## **Re: Hertford Theatre, Hertford – Planning Condition 4**

Temple was contacted by GPF Lewis during November 2023 with regards to reviewing information to support the discharge of Condition 4 for the planning application submitted for Hertford Theatre, Hertford (reference: 3/20/2285/FUL).

This is a letter from Temple for GPF Lewis which documents the specification for a selection of boxes targeting bats, birds and bees for the development at Hertford theatre.

Figure 1: Bat, Bird and Bee Box Plan (Fabrik, 2023d)

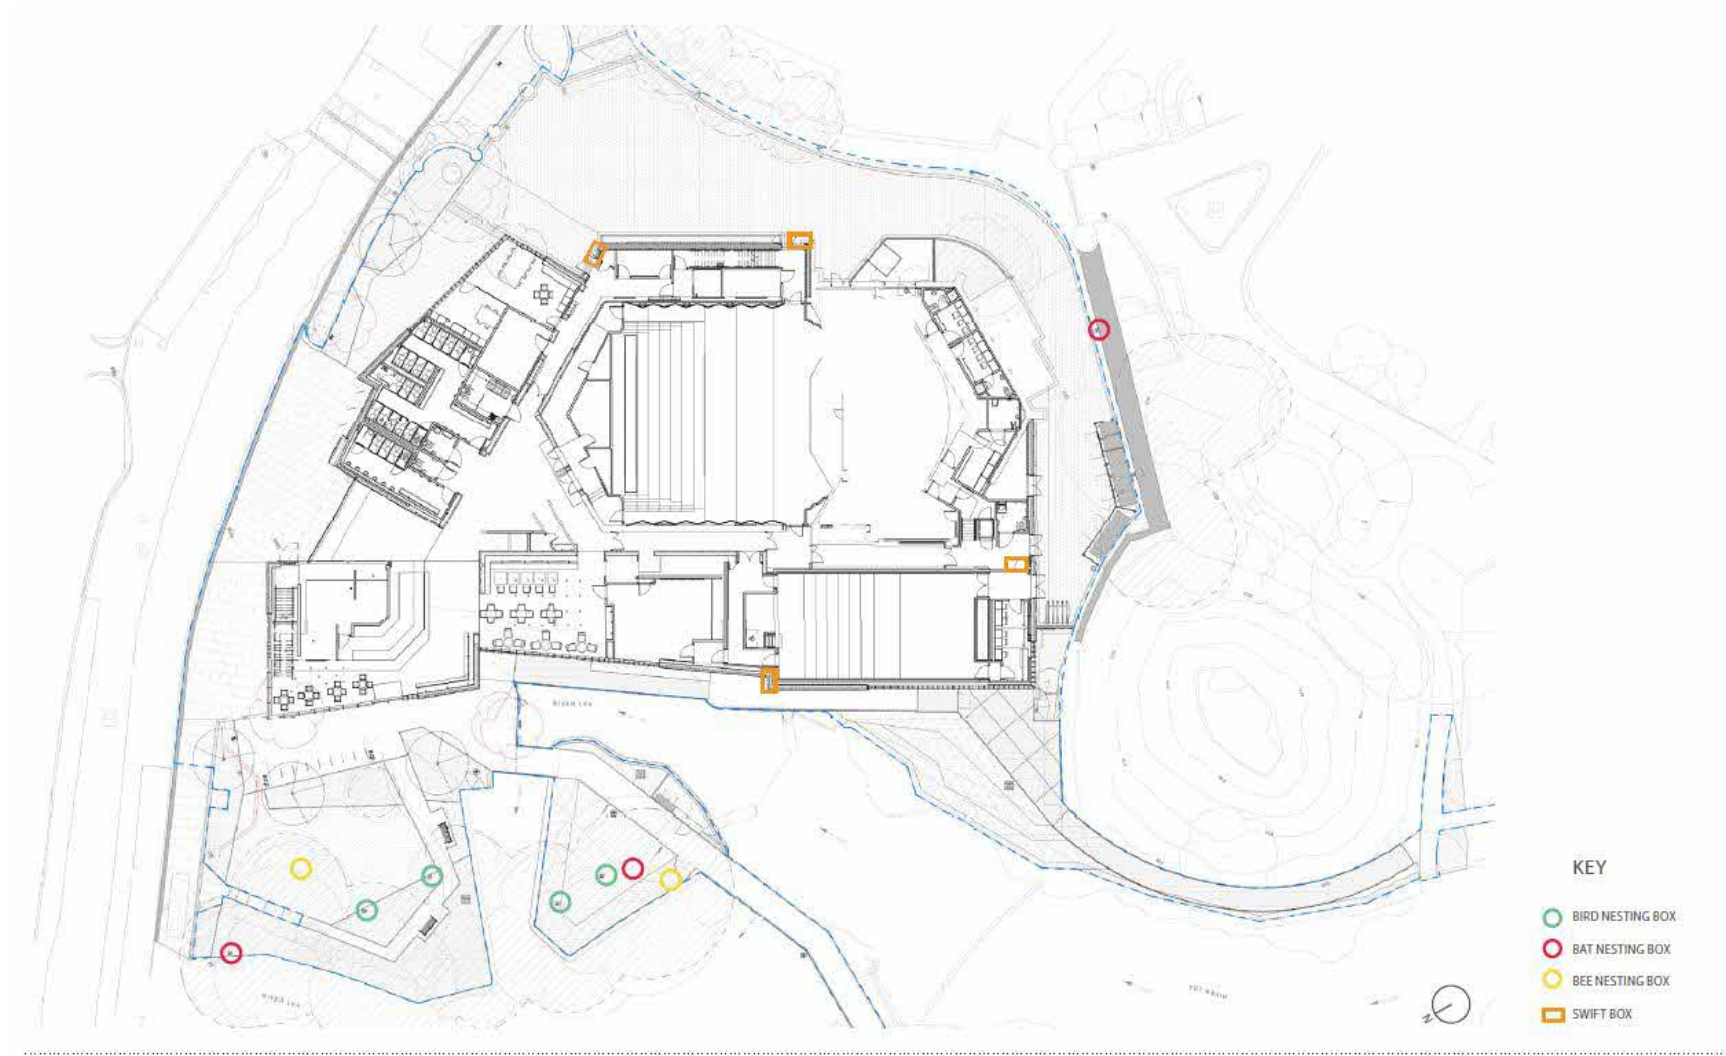
Originally, one bat box was proposed to be installed on a tree in the west and two on the wall in the south of the site. Upon review of the bat box locations and the lighting study (Pritchard Themis, 2023), Temple advised that one of the bat boxes be moved from the wall in the south, to a tree in the west subject to lower lux levels and in a location with connectivity to the river and proposed meadow lawn which are suitable for foraging and commuting, to increase the likelihood of it being used. This has been amended, as shown in Figure 1, Appendix 1.

Temple have reviewed the proposed location, number and specification of the bat, bird and bee boxes (Fabrik, 2023d), along with landscape plans (Fabrik, 2023a-c) and lighting plans (Pritchard Themis, 2023, Temple 2024a). We did not provide advice or comment on the swift boxes as these were already built into the new building. However, we can confirm all other boxes meet recommended specifications and numbers and are in suitable locations. This letter should be read in conjunction with the lighting review letter and the Landscape and Ecological Management Plan (Temple, 2024a, b).
